Flood Map Update

MR096 Monaghan

PROJECT	Flood Map Update – MR096 Monaghan
PROJECT NO.	MR096
PROJECT ENGINEER	Cian Ó Fátharta
DOCUMENT TITLE	MR096 Monaghan Report

Figure 2: Current Scenario Flood Extents at the Rossmore Factory

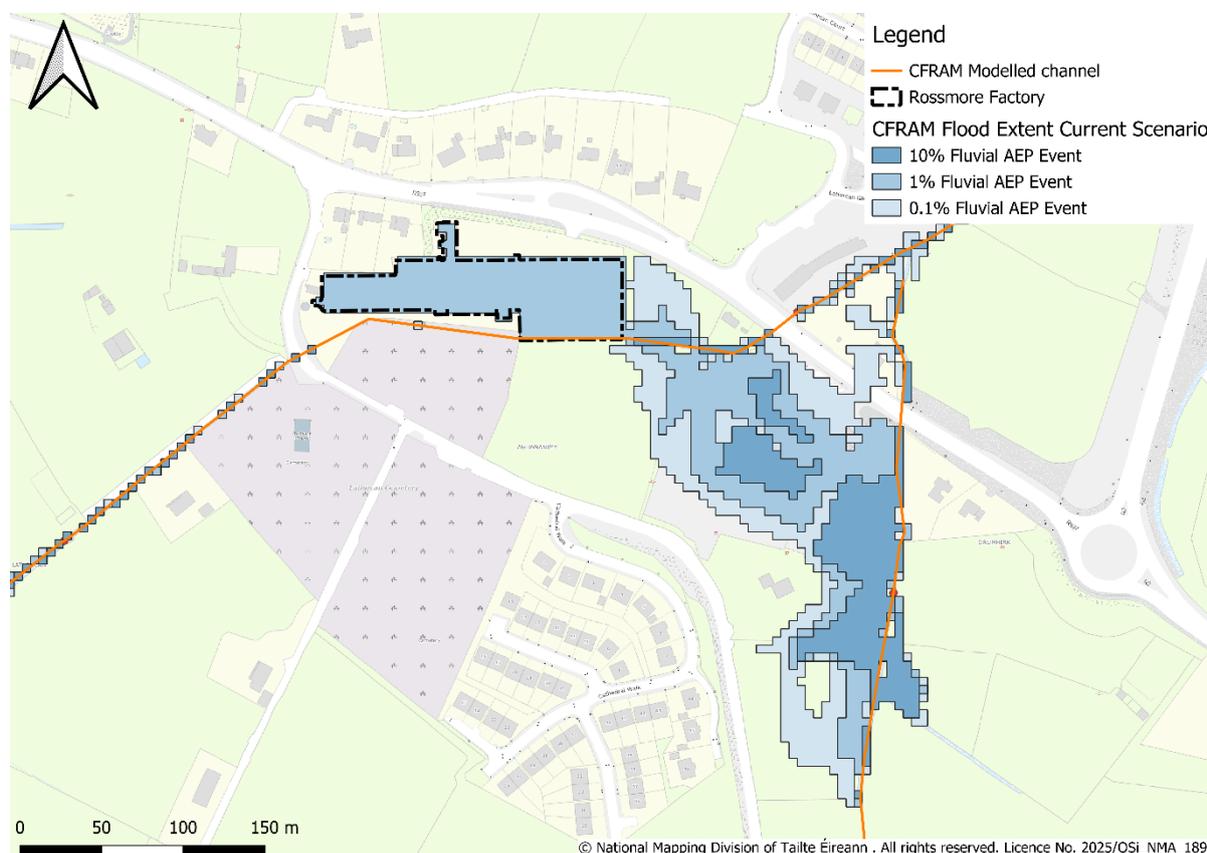
The OPW will only carry out a Map Review when the information provided supports one of the criteria described in Section 1. In the case of the Rossmore Factory, an error was identified in the flood extents. The CFRAM flood extents show the entire factory floor area within the flood extent of the current scenario 2% AEP flood and higher magnitude events, despite the factory's finished floor level (FFL) being above the surrounding flood levels.

During the hydraulic modelling for the North Western – Neagh Bann (NWNB) CFRAM, buildings were blocked out so floodwater was unable to flow through them. As part of the post processing of the modelling results, any building that touched a flood extent was then infilled by default. The flood extents for the current scenario 2% AEP and higher magnitude events overlap the factory outline and hence the factory building was infilled and shown to be within these flood extents. See Figure 2 below.

The CFRAM flood extent and depth maps were updated for the Rossmore Factory in Monaghan. The GIS data was updated by cutting out the factory floor area from the relevant flood extents and depths. The flood events for which the factory floor area was removed from the flood extents and depth results are listed in Table 3.

Figure 3: MRFS Scenario Flood Extents at Rossmore Factory

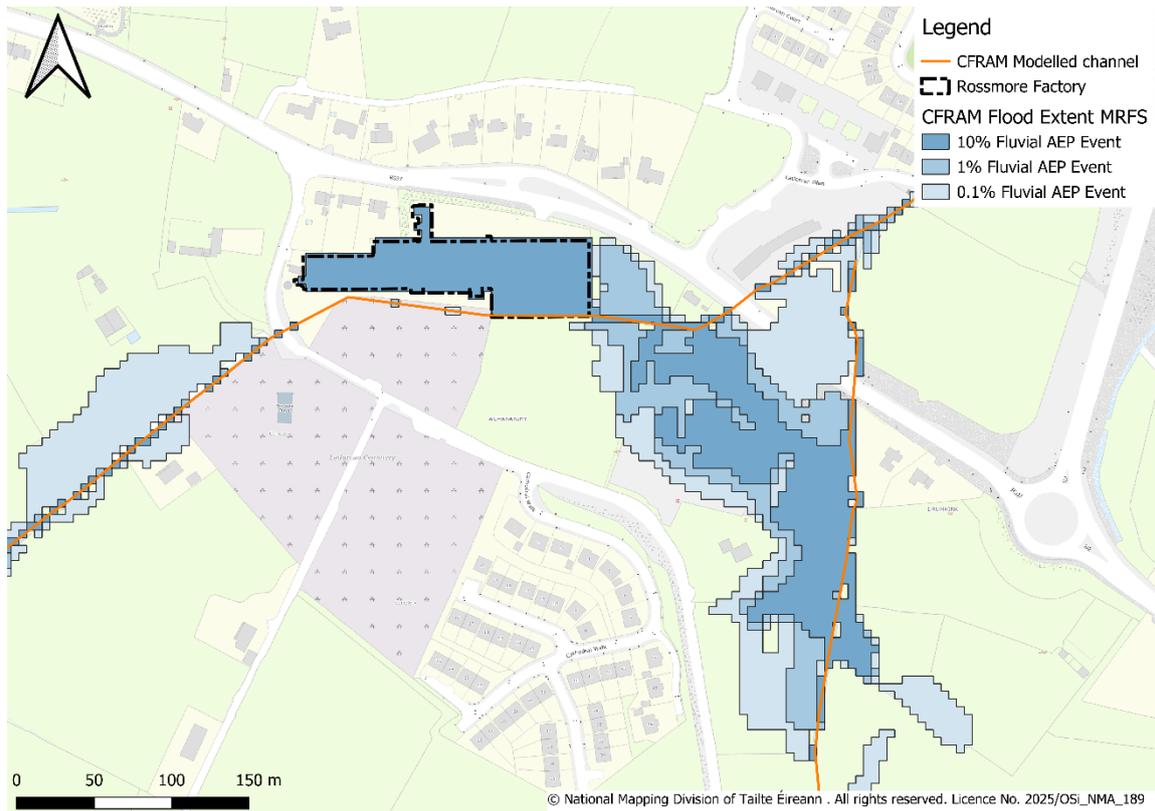
The flood extents for the MRFS 10% AEP flood and higher magnitude events overlap the factory outline and hence the building was infilled during post processing and shown to be within the flood extent. See Figure 3. The same goes for all the HEFS events as shown in Figure 4 further below.
